Rear Suspension Hub Carrier Fulcrum Bolts –  
Revised Specification –  
Replace – Service Action S468

MODEL  
1998 MY XK8 Range  
1998 MY V8 XJ Series  
VIN  
025588-026519  
837386-840302

ILLUSTRATION 1

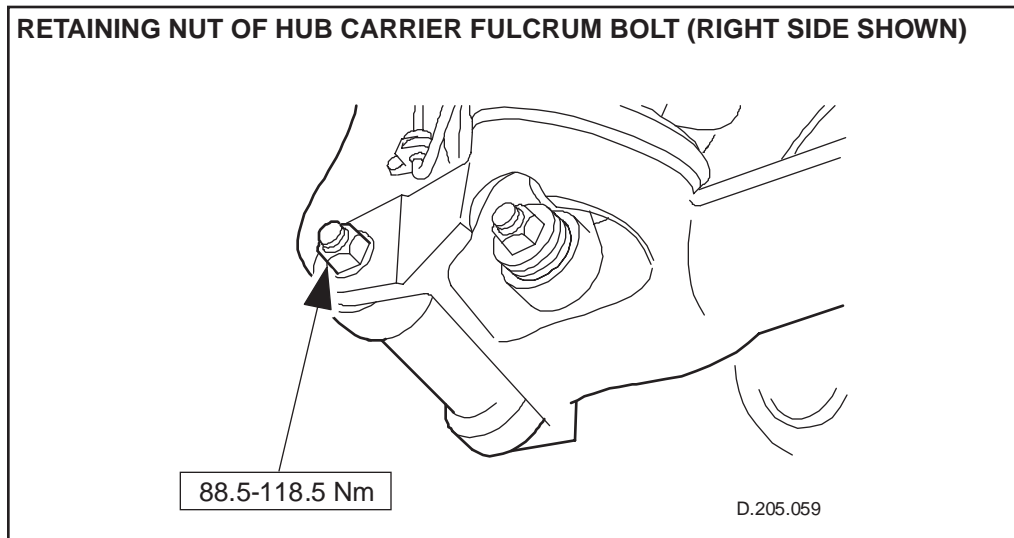
Some 1998 MY vehicles within the above VIN ranges may have outer fulcrum bolts of the incorrect specification in the rear suspension. The fulcrum bolts connect the rear hub carriers to the outer ends of the rear suspension wishbones.

1. Raise the vehicle on a lift so that the rear suspension arms are supported while still allowing access to the nut (Illustration 1) and also to the head of the fulcrum bolt (Illustration 2).

4. Remove the retaining nut from the fulcrum bolt on one side of the vehicle and retain the washer for reuse.
5. Supporting the hub carrier in position and use a short drift approximately 14 mm. in diameter to drive out the fulcrum bolt toward the rear. Discard the bolt and nut.

6. While still supporting the hub carrier in position, install the replacement bolt from the rear. Rotate the bolt as necessary to allow the eccentric head of the bolt to fully seat in the guide slot in the wishbone. Align the marker line on the head of the bolt with the line previously scribed on the wishbone in step 3. Install the washer with a **new** self-locking nut, and tighten until the bolt begins to grip, ensuring that the marker line on the bolt head remains aligned to the scribed line.

ILLUSTRATION 2

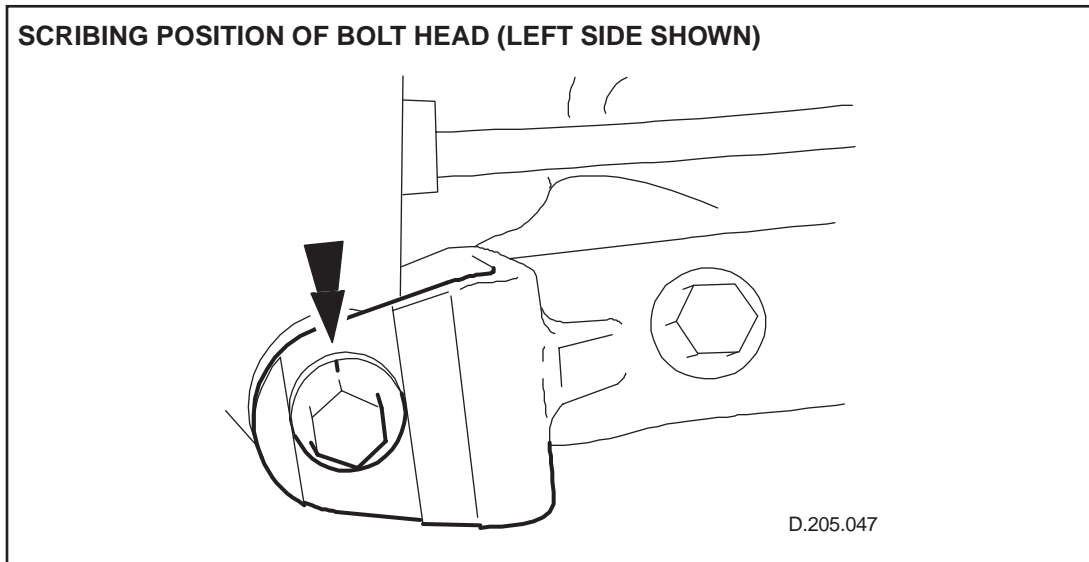
2. Remove the rear road wheels.
3. If necessary, clean the head of each fulcrum bolt so as to be able to identify the marker line stamped on the head of each bolt (Illustration 2). Use a fine-pointed scribe to mark on each wishbone the location of the marker line, prior to dismantling. The marker line will not necessarily be in the location illustrated, depending on previous adjustment to effect correct wheel alignment.

11. With the rear tires standing on turntables, apply wheel alignment equipment to the vehicle. Check that the rear camber and toe measurements are within the figures in the table below. If necessary, rotate the fulcrum bolt so that its eccentric head adjusts the position of the lower end of the hub carrier to obtain readings within the stated limits. After completing the adjustment, tighten the fulcrum bolt retaining nut to 103 +/- 15.5 Nm (76 +/- 11.4 lb. ft.), ensuring that the position of the bolt head is not moved.
